LINDFIELD LEARNING VILLAGE

RESPONSE TO SUBMISSIONS - BUILT HERITAGE

12 SEPTEMBER 2019
PREPARED FOR SINSW

Figure 3 – Removal of fire wall as shown highlighted.

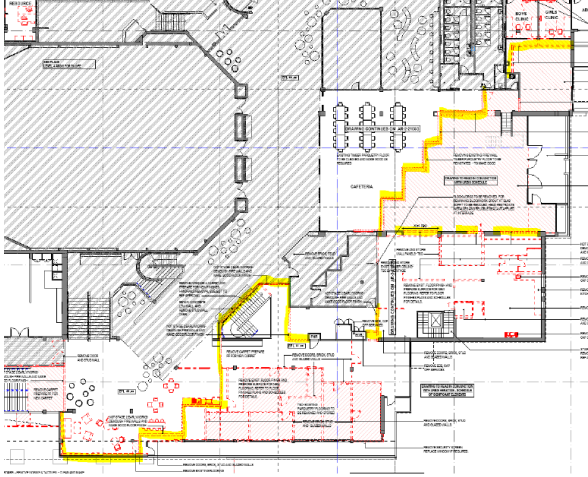
A fire wall was constructed between the northern section of the school and Phases 2 and 3 in order to facilitate the implementation of the partial school. Urbis acknowledged that this item of work would impact the quality of the spaces (including the cafeteria and the central circulation spine). Urbis supported the construction of the fire wall (refer Urbis letter dated 24 August 2018) only on the basis that it was reversible, required in order to implement the school by the required time and on the basis that it would be removed pending the implementation of the remainder of the school. Urbis not only strongly supports the removal of the fire walls but considers this item of works to be necessary in mitigating the detrimental heritage impact generated by the construction of the fire wall.

In Urbis Response to Submission letter (August 2018) the fire wall was identified to be an ad hoc addition which would intersect key spaces including the cafeteria and the central circulation spine. The removal of the fire wall is strongly supported to reverse the detrimental impacts generated by the construction of the fire

wall. The fire wall was installed as a temporary measure and can be removed without any impact on the significant fabric in the space.

Figure 6 – Revised SSD proposal showing rooftop additions omitted from revised scheme.

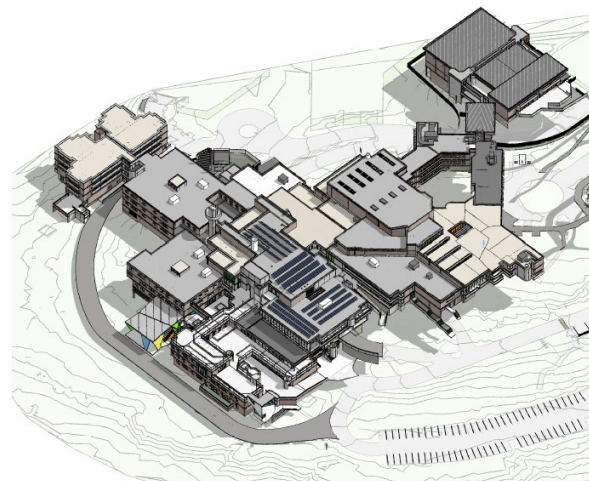
Three covered outdoor learning areas (COLAs) were initially proposed to the rooftops in order to fulfil the operational requirements of the building. These were discernibly new structures and were supported on the basis that they would appropriately respond to the strength in the original form of the heritage item. They would also be set back from the existing building facades. The extent of 'coloured' external cladding was subsequently reduced after the exhibition of the EIS and confined to discrete areas of the external facades and COLA structures to minimise the prominence and visual impact on the building.

The revised SSD submission addressed in this letter omits the rooftop additions entirely from the scheme. Although the rooftop additions were supported in the initial scheme as above there is recognised benefit in their omission from a heritage perspective. Policy 36 of the CMP acknowledges the response that the existing building forms have to the landscape i.e. that they retain the stepped and modulated response characteristic of the Sydney Style with the lower levels to the south of the building. The omission of the rooftop additions would ensure that there is no potential for any items to obscure this relationship.

The removal of the rooftop play areas would further encourage the use of the surrounding bushland by the students and enhance the relationship between the use of the building and its setting.

Figure 9 – Proposed demolition plan showing removal of the link and planter.

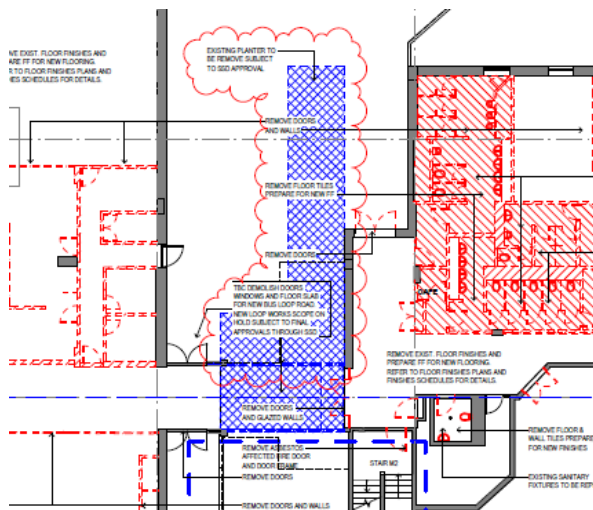
The proposed demolition affects the ground floor section of the link and the bulk of fabric to be removed to facilitate this addition constitutes the anodised glazing which is attributed little significance in the CMP (Urbis 2018). The first-floor connection is retained over the road and the original configuration of the link remains able to be interpreted. The works would however require the removal of the slab at Level 1 and the removal of the planter box adjacent to the link (north).

The removal of the planter box would have some heritage impact as the planter boxes are part of the original landscape planning of the school and are preferred to be retained in accordance with Policy 44 of the CMP. The subject planter box to be removed however is located in an area of lesser significance and in the context of what is considered to be a service/utilise courtyard. This courtyard includes roller doors and access to carparking. The planter box does not demarcate a major entrance to the building and its removal would facilitate the resolution of a long-established traffic issue associated with the site.

Figure 18 – Proposed Level 4 entrance steel frame layout.
Source: DesignInc.

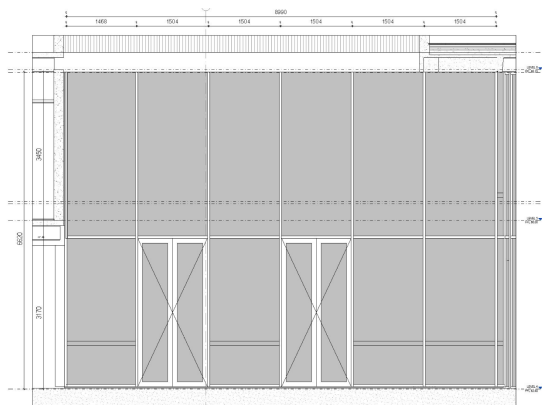
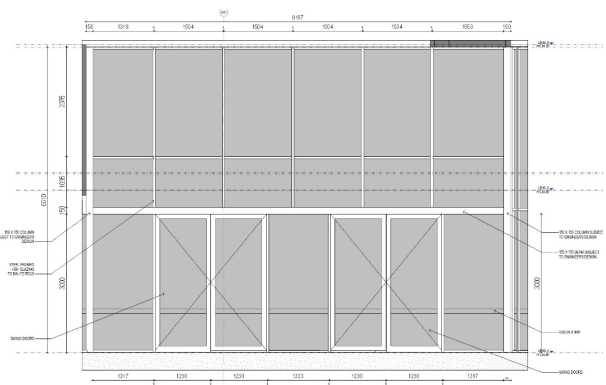
DesignInc in collaboration with Urbis have developed a solution for the proposed entry at Level 4. Not that doors required for fire egress including those at level 4 are ideally not to be covered by shutters. As such, the Level 4 entry is required to be reconstructed in steel.

The same principles have been applied to this entry as to the main entry at Level 5. As per the main entry the double height entry is not able to have the steel frame elements in the same alignment as larger fire doors are required to the lower floor. As such, the existing alignment of the framing to the upper half of the entry with the waffle slab axis has been prioritised.

The size of the steel frame & fire rated glass does limit the panels to 3.1 x 1.3, which is shorter than the existing. In order to keep the primary horizontal breakup of the entry a second horizontal member has been added above the member which will be replaced at the existing level.

It is considered that the above resolution of the design was successful from a heritage perspective in the delivery of the Phase 1 school. It is considered entirely appropriate from a heritage perspective that the same principles are applied to the Phase 2 school.

Figure 20 – Proposed demolition to southern façade.

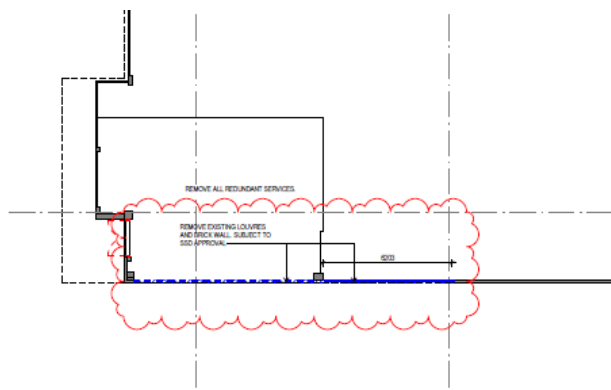
A small amount of demolition of the south façade at level 1 is proposed to allow for the introduction of doors to this façade and enhance permeability of the building. This item of work would include the removal of existing louvres and small sections of brick wall to the south façade. The southern façade of the building is of high significance for its overall form and composition of materials which are highly characteristic of the architectural style, and specifically its concrete detailing including exposed slab and window hoods.

The proposed demolition at level 1 would impact only anodised windows which are graded as little significance in the CMP (Urbis 2018) and a small amount of brick. The windows are not part of a significant fenestration pattern and therefore the demolition is in line with Policy 37 of the CMP which stipulates that significant rhythms of fenestration to the southern façade are not to be disrupted.

The new opening would retain the same header height as the existing windows and would therefore have no impact on the exposed concrete slab edge above.

There are no other existing openings proposed at this level on this façade. As such, the new larger openings would not disrupt an existing fenestration pattern. The new doors at this level are proposed to be black and in keeping with the existing profile of windows and doors throughout.

Figure 23 – Revised SSD proposal showing revised COLA design.

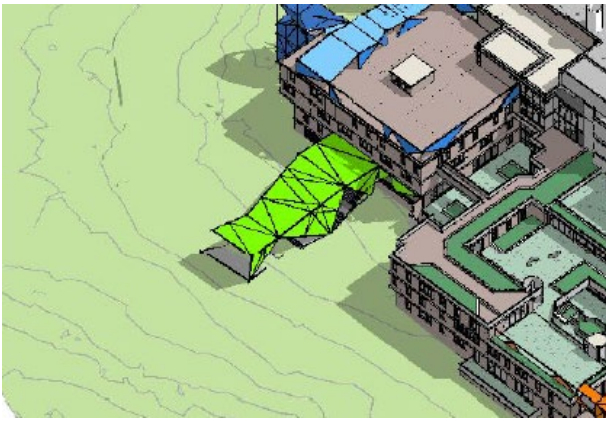
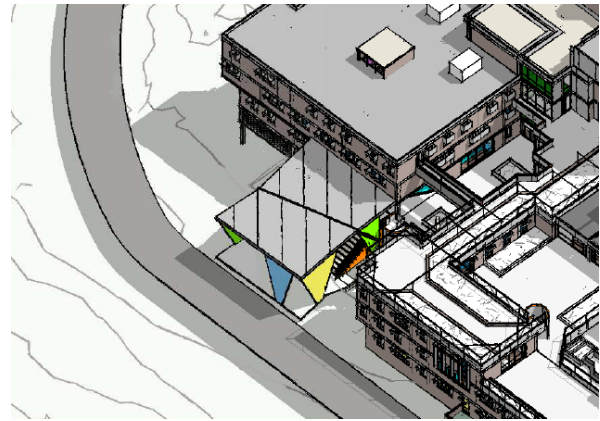
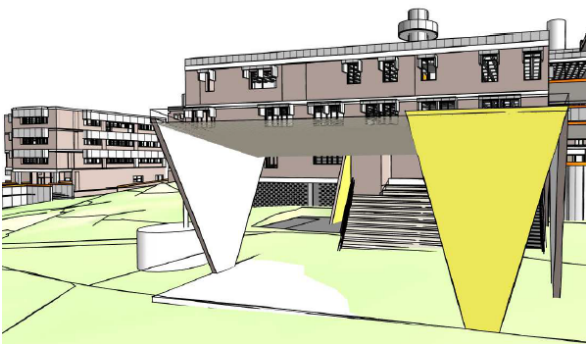
The proposed COLA has been shortened and widened in contrast to the original SSD submission. The COLA would also function as a bus stop in addition to a shade structure.

As per the original design, the COLA would remain under the height of the exposed slab at Level 3. Note that the COLA has been specifically designed such that there is no impact on the characteristic spiral stairs to the east of the COLA which are of high significance. These design elements ensure the COLA continues to respond to Policy 29 of the CMP which stipulates that new works are not to diminish the interpretation of principal elevations.

The original design principles (origami and colour in contrast to the existing concrete and solid construction) are featured in the revised design and are in accordance with Policy 51 of the CMP.

Figure 32 – Wall to be partly demolished.

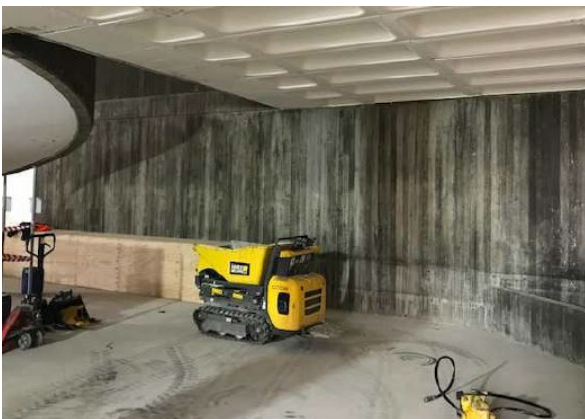
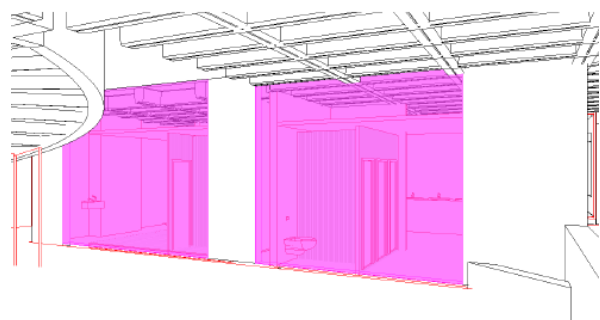
The partial removal of the concrete wall adjacent to the spiral stairs at the secondary entrance (Level 4) is proposed to increase the light permeation through the building (Please refer to drawing AR-2-2104J & AR-2-2304J for details). The proposed demolition includes the removal of two portions of wall (3853mm wide and 3376mm wide x 2.7 metres high).

It is considered that the opening of the wall behind the staircase would give further prominence to the spiral staircase which is of high heritage significance and would not unreasonably detract from the overall character of the concrete materiality. The requirement for light permeation throughout the building is further acknowledged.

The structural engineering report has confirmed that the removal of the portion of concrete wall as proposed would have no impact on the structural integrity of the wall above or the adjacent stair.

Figure 34 – Wall to partly be demolished.

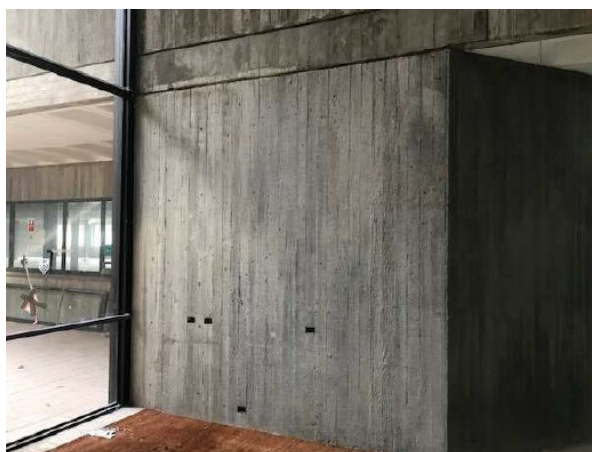
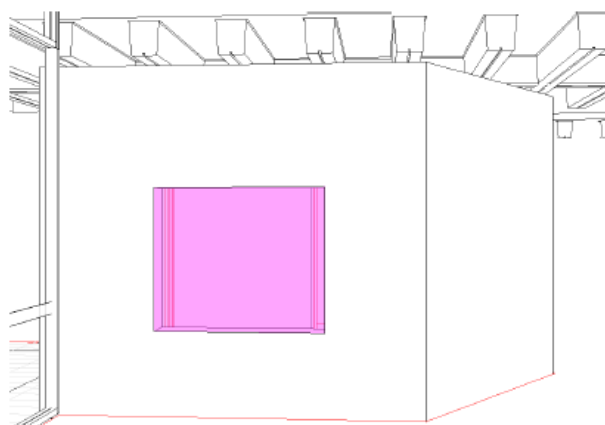
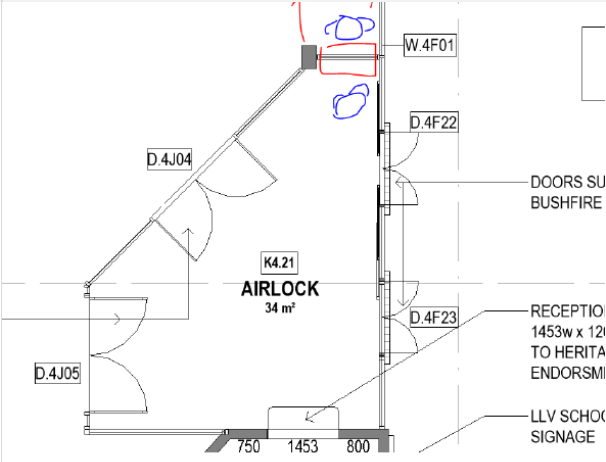
The cut out of an opening within the concrete element at the Level 4 Main Entry is required to enable a functioning reception to operate at the entry. Please refer to drawing AR-2-2104K & AR-2-2304K for details.

A number of options for the implementation of the reception area have been investigated in consultation between DoE, Urbis and DesignInc. These options have been set out in the table below and against each the identified heritage impact is set out.

All of the proposed options have a material heritage impact. The preferred option is option 3 which has been copied below. It is acknowledged that this option will have an adverse material impact which would be essentially not reversible (Policy 27 of CMP). However, it is understood that the reception facility is an essential operational requirement and is partly facilitated by Policy 60 of the CMP which allows some change for access. To this end the preferred option involves the least impact (considering both visual and physical impacts).
